# 1200-1340 OLD BAYSHORE HIGHWAY PROJECT

## Response to Comments Document

Prepared for  
City of Burlingame

February 2024

**Revised Figure 3-4**  
Proposed Ground Level Site Plan

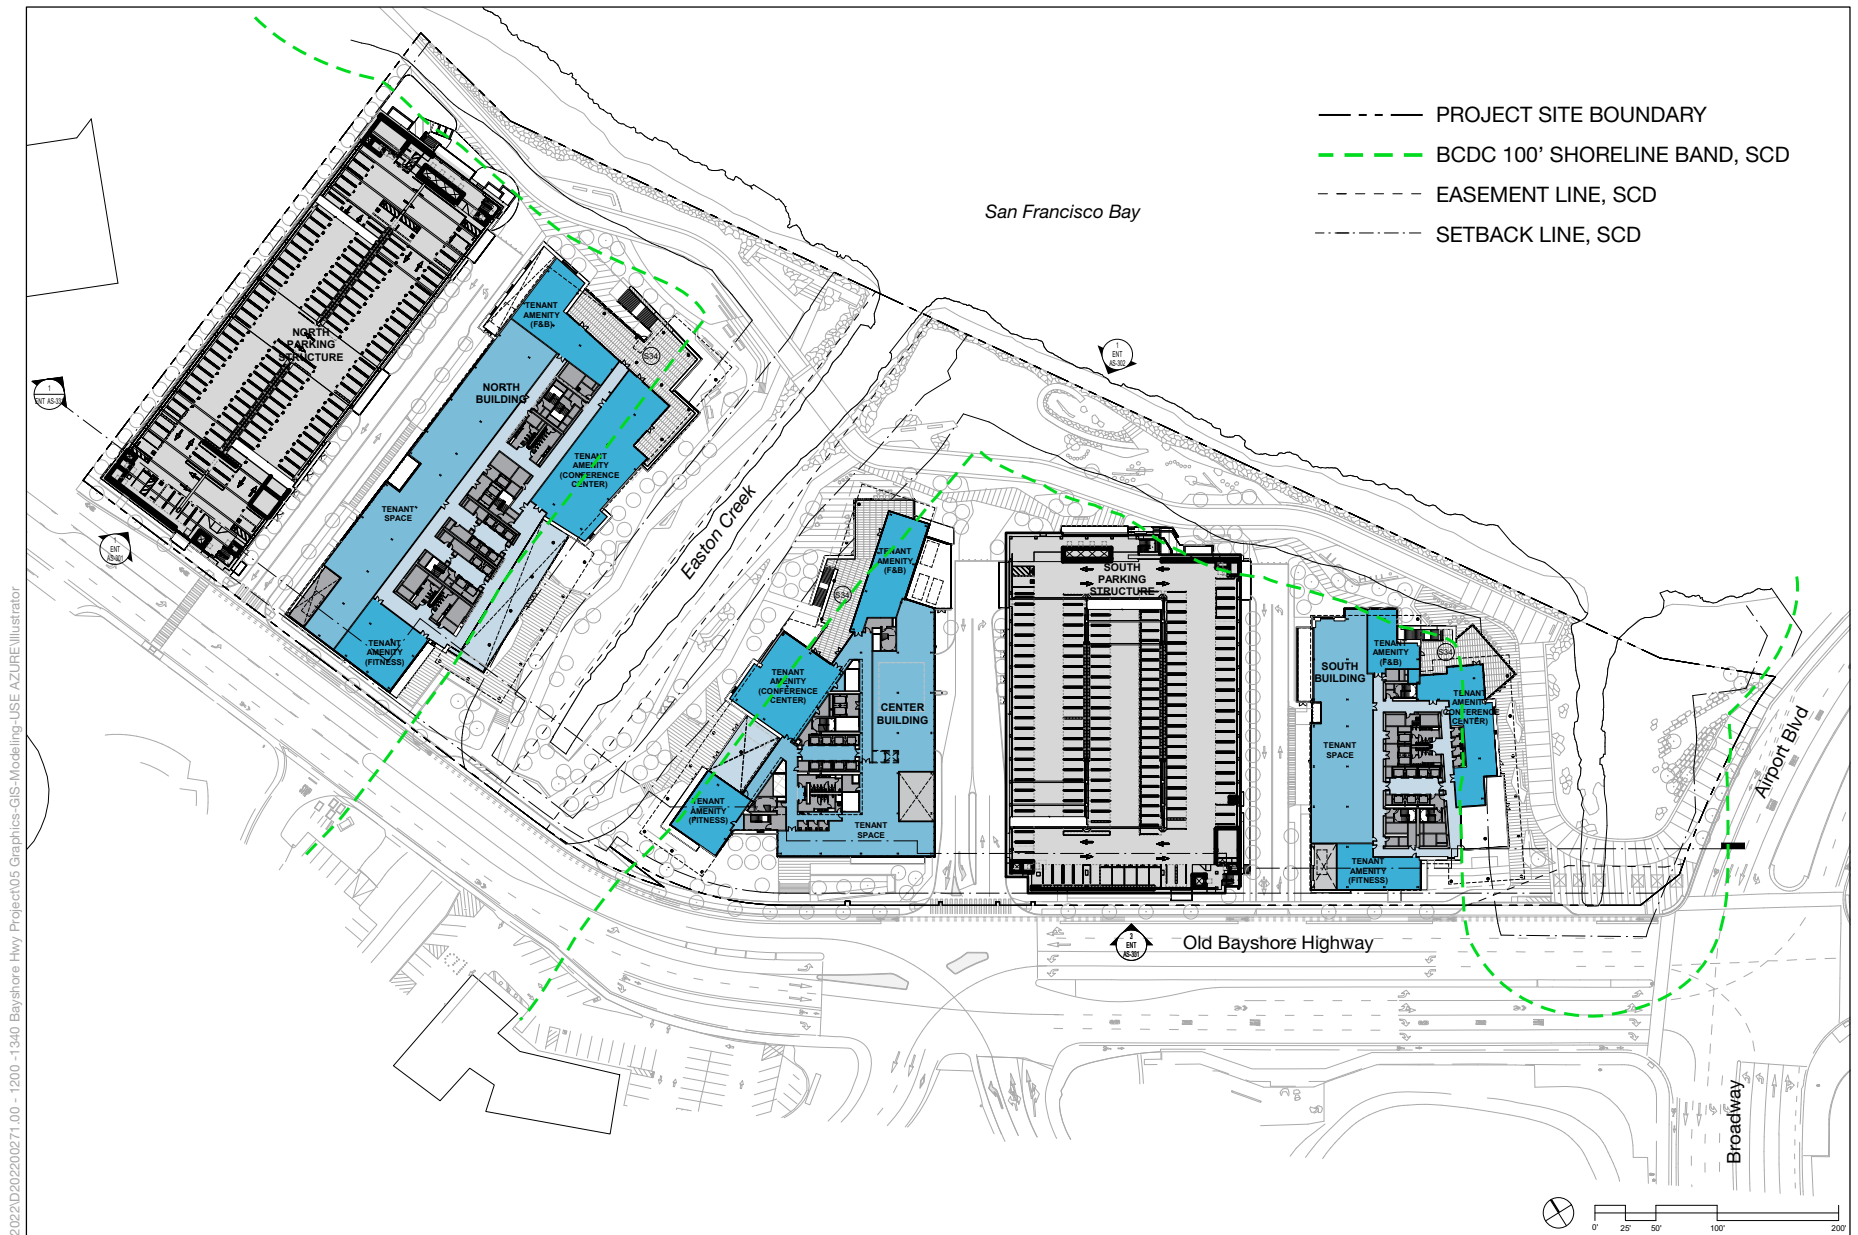
- The comments are acknowledged, no response is required.
- A-BCDC-3      The commenter indicates the BCDC jurisdictions depicted in Draft EIR Figures 3-4 through 3-7 appear to be from an older understanding of its jurisdictional limits. The commenter indicates the notes in Figure 3-4 are not legible in the DEIR PDF, and should be made larger and more clear. The commenter requests at least one figure in the EIR with current information and ensure that it is clearly labeled.

- Figures 3-4 through 3-7 have been revised to reflect the current BCDC 100-foot shoreline band; labels and titles for jurisdictional limits on the figures have been made clearer; and Figure 3-4 is enlarged from an 8½ x 11-inch to a 11 x 17-inch dimension. Please refer to Chapter 4, *Revisions to the Draft EIR*, of this Response to Comments document for the revised figures.
